L-12-271

Beaver Valley Power Station, Unit Nos. 1 and 2

License Amendment Request to Modify Technical Specification 3.1.3, "Moderator Temperature Coefficient Measurement (MTC)," to Provide an Exemption Under Certain Conditions

## Evaluation of the Proposed Amendment

Figure 5.1-5 (Page 1 of 1)

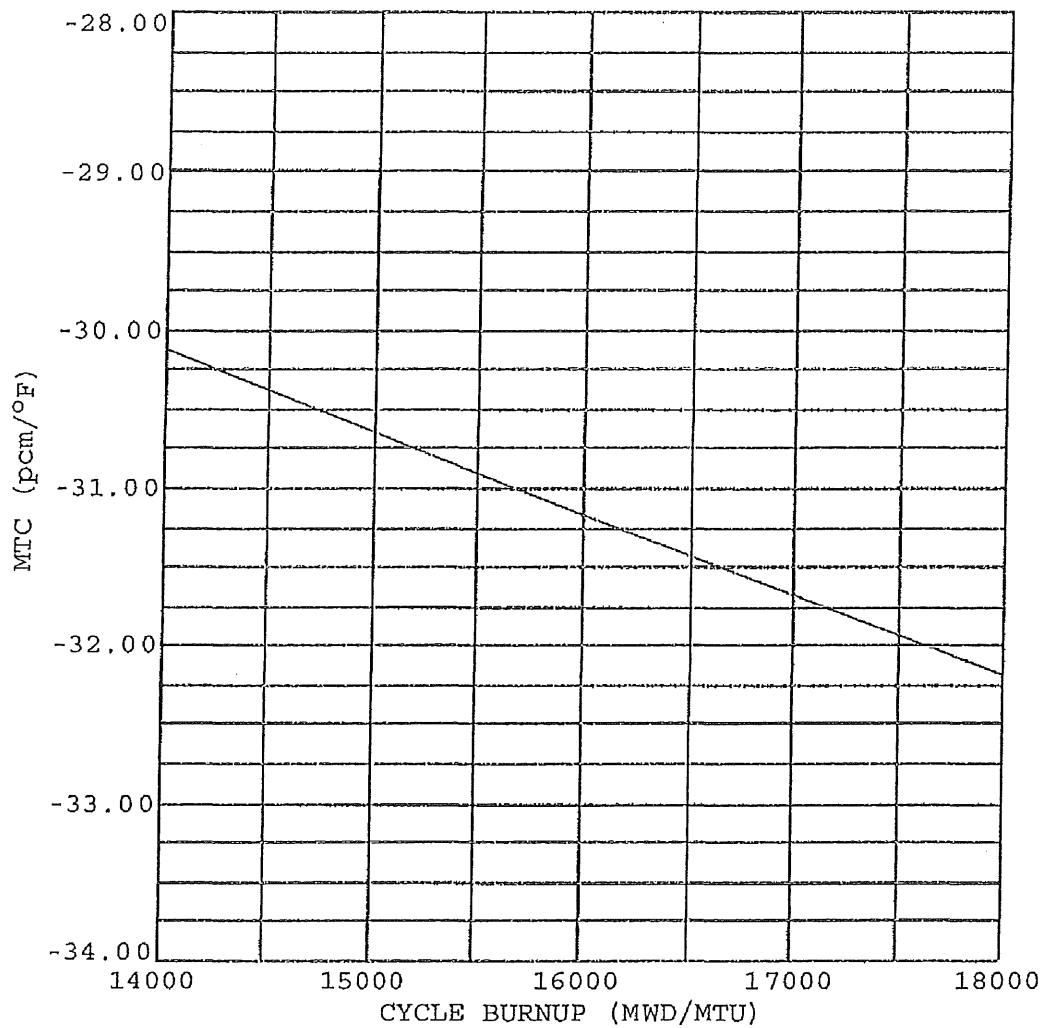
- a. Upper Limit - MTC shall be maintained within the acceptable operation limit specified in Technical Specification Figure 3.1.3-1.
- b. Lower Limit - MTC shall be maintained less negative than  $-4.4 \times 10^{-4} \Delta k/k/^{\circ}F$  at RATED THERMAL POWER.
- c. 300 ppm Surveillance Limit:  $(-37 \text{ pcm}/^{\circ}F)$
- d. The revised predicted near-EOL 300 ppm MTC shall be calculated using Figure 5.1-5 and the following algorithm from Reference 11:

Revised predicted MTC = Predicted MTC + AFD Correction + Predictive Correction

If the revised predicted MTC is less negative than the SR 3.1.3.2 limit (COLR 5.1.3.c) and the benchmark criteria contained in WCAP-13749-P-A are met, then an MTC measurement in accordance with SR 3.1.3.2 is not required.

Figure 5.1-5 (Page 1 of 1)

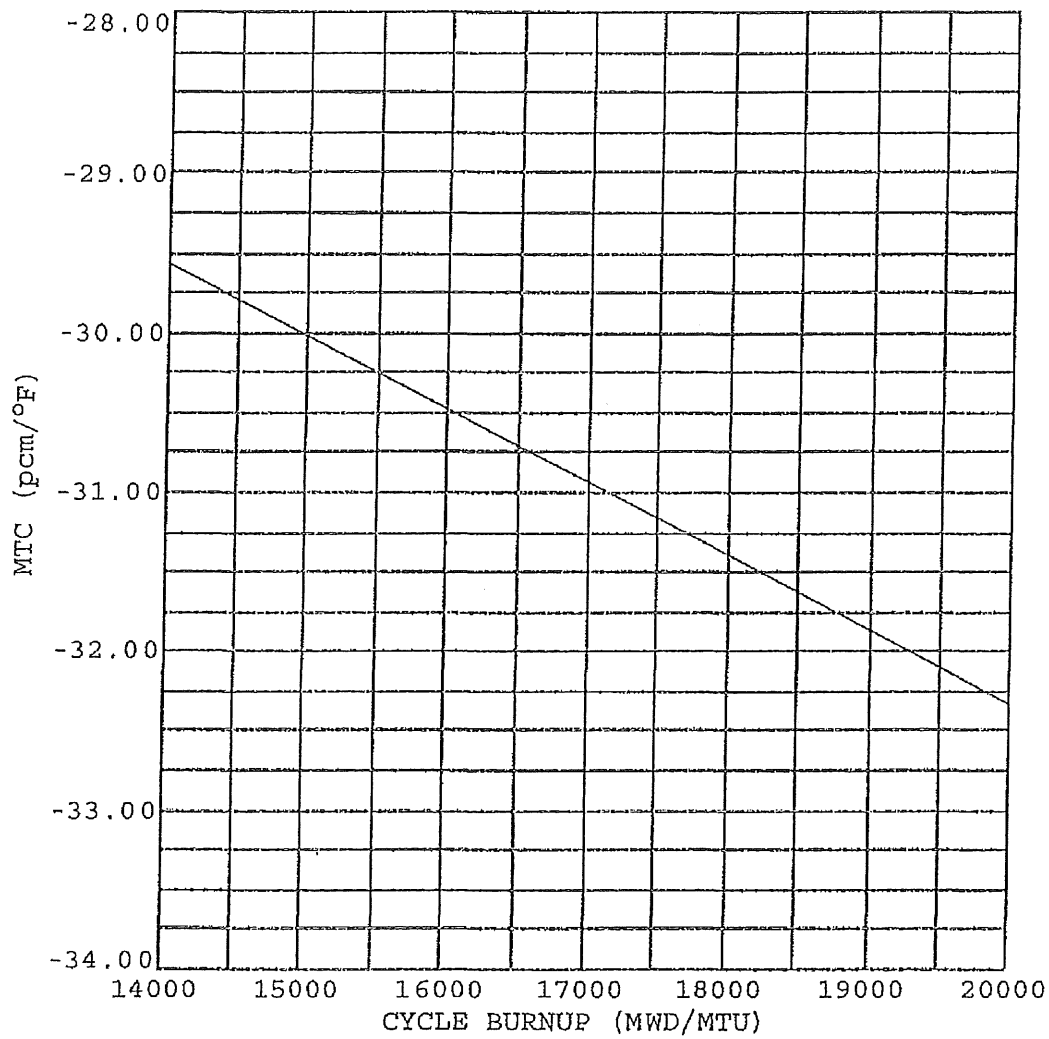
- a. Upper Limit - MTC shall be maintained within the acceptable operation limit specified in Technical Specification Figure 3.1.3-1.
- b. Lower Limit - MTC shall be maintained less negative than  $-4.29 \times 10^{-4} \Delta k/k/^\circ F$  at RATED THERMAL POWER.
- c. 300 ppm Surveillance Limit:  $(-35 \text{ pcm}/^\circ F)$
- d. The revised predicted near-EOL 300 ppm MTC shall be calculated using Figure 5.1-5 and the following algorithm from Reference 10:

Revised predicted MTC = Predicted MTC + AFD Correction + Predictive Correction

If the revised predicted MTC is less negative than the SR 3.1.3.2 limit (COLR 5.1.3.c) and the benchmark criteria contained in WCAP-13749-P-A are met, then an MTC measurement in accordance with SR 3.1.3.2 is not required.
